Subject: Docket No. 50-482: Response to NRC Requests for Additional Information Related to Wolf Creek Generating Station License Renewal Application Time-Limited Aging Analysis Audit Question

**Wolf Creek Nuclear Operating Corporation (WCNOC) Response to NRC Requests  
for Additional Information RAI 4.3-1**

**Case Study: A Comparison of FatiguePro 1D Stress Analysis to ASME Six Tensor Component Stress Intensity Analysis for Fatigue Usage Factor Calculations**

**Figure 3: Membrane-plus-Bending Stress Intensity Range**

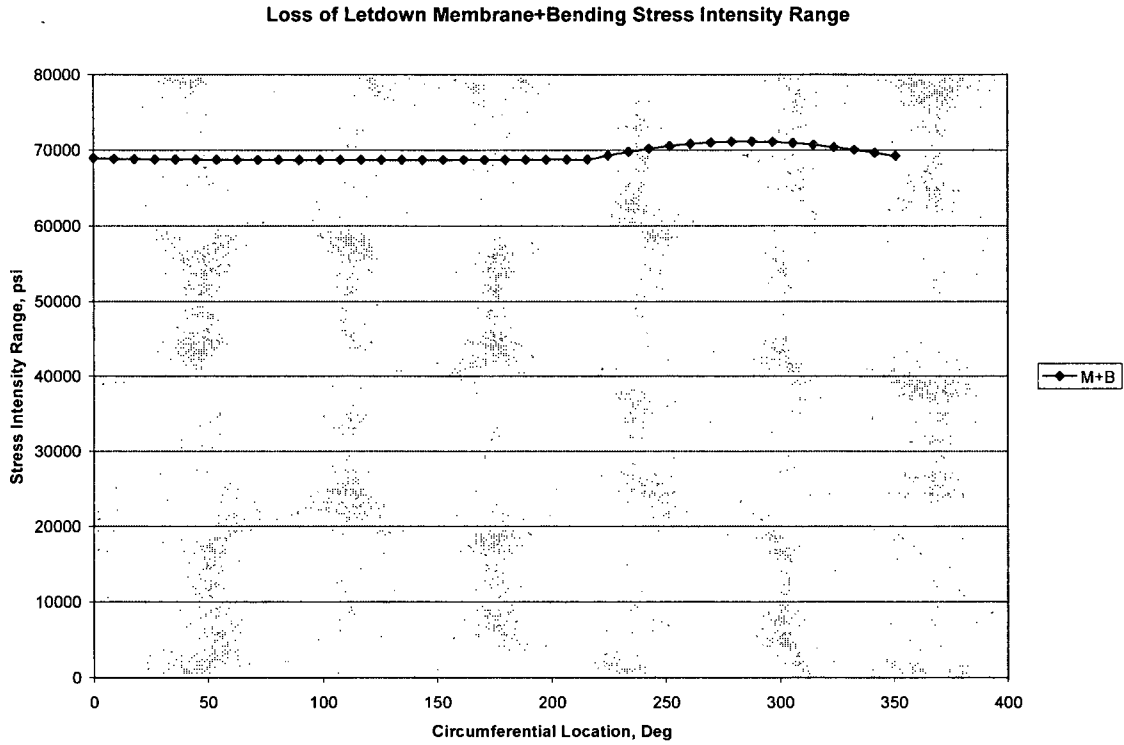
The peak stress intensity range for the same transient computed by a 3D finite element analysis was less than 71.2 ksi per Figure 3, with a maximum  $K_e$  of 2.40 (Figure 4) and a corrected stress range of less than 252 ksi (Figure 5).

**Figure 6: Membrane-plus-Bending Stress Intensity Range**

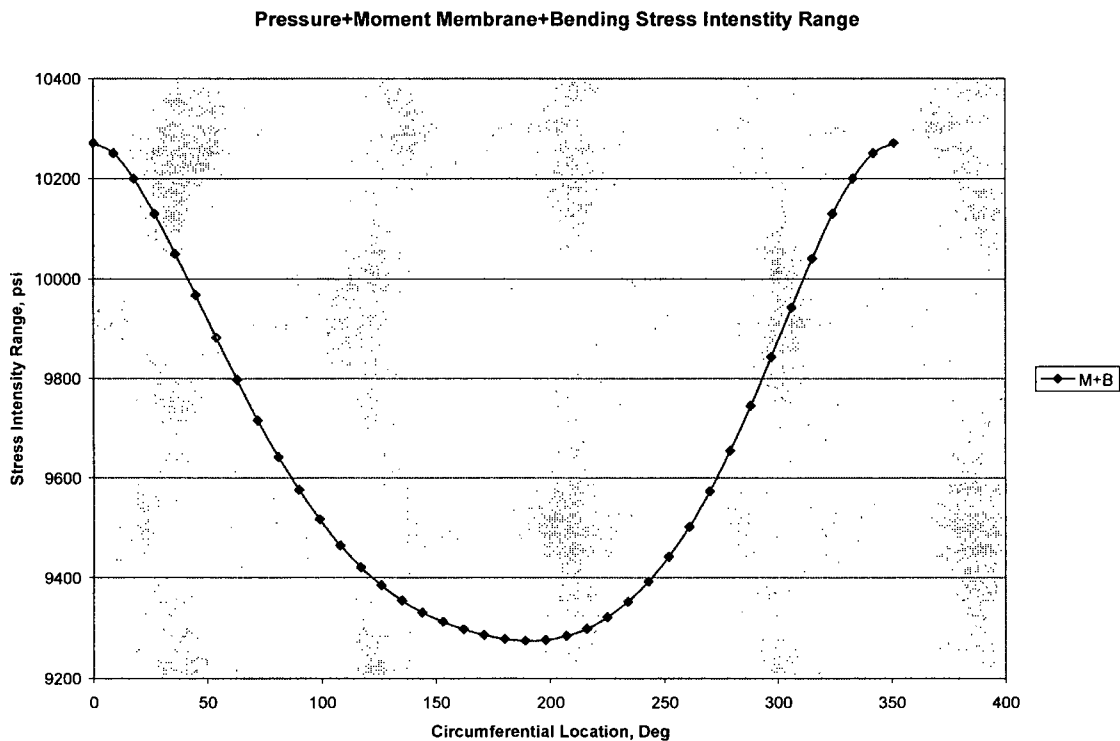
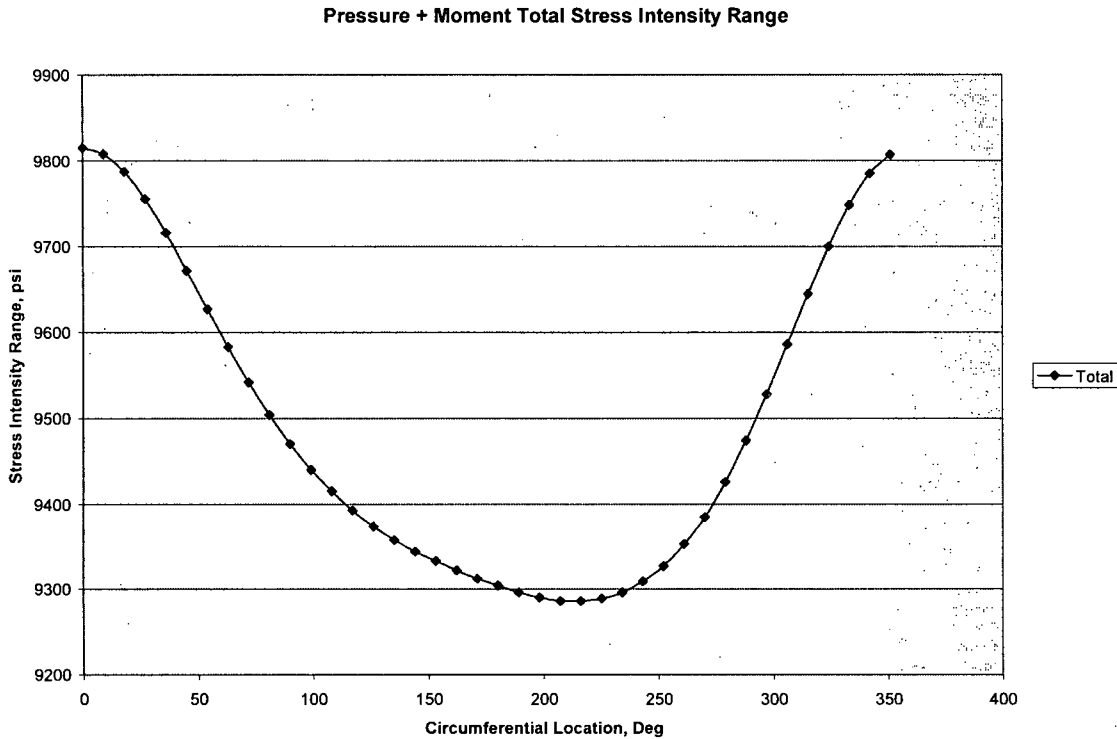
The peak stress intensity range for the same condition computed by a three-dimensional finite element analysis was less than 11 ksi per Figures 6 and 7.

Figure 10: FatiguePro Fatigue Details Table for Transient 1

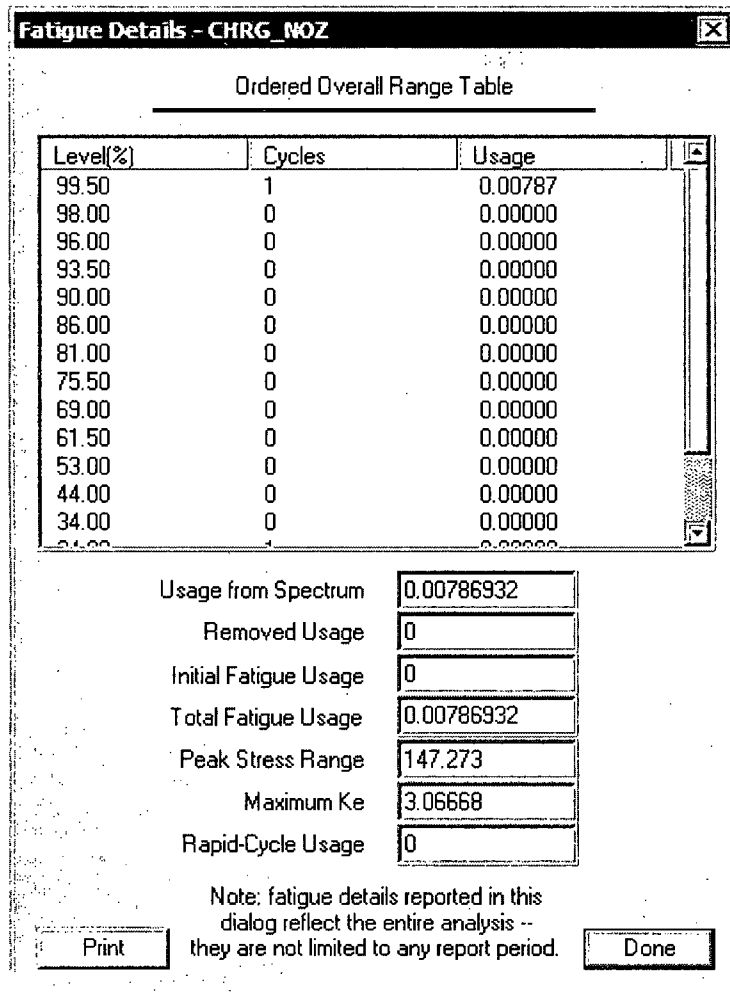
From that report, you can see that the fatigue usage is determined by a single stress pair, with a (total) stress intensity range of 147.3 ksi. A corresponding Ke factor of 3.067 is applied, giving a usage factor of 0.00787. (Note that the stress intensity range for the simulated cooldown/heatup transient is too small to have a significant effect on the computed fatigue usage.) The local temperature transient is shown in Figure 11. Figure 12 shows the resulting stress history, with the fatigue-significant portion zoomed-in in Figure 13.

The peak stress intensity range for the fast Loss of Letdown transient computed by FatiguePro was 147.273 ksi with a maximum  $K_e$  of 3.07 (see Figure 10). Multiplying the linear elastic stress range by  $K_e$  results in a corrected stress range of 452 ksi.
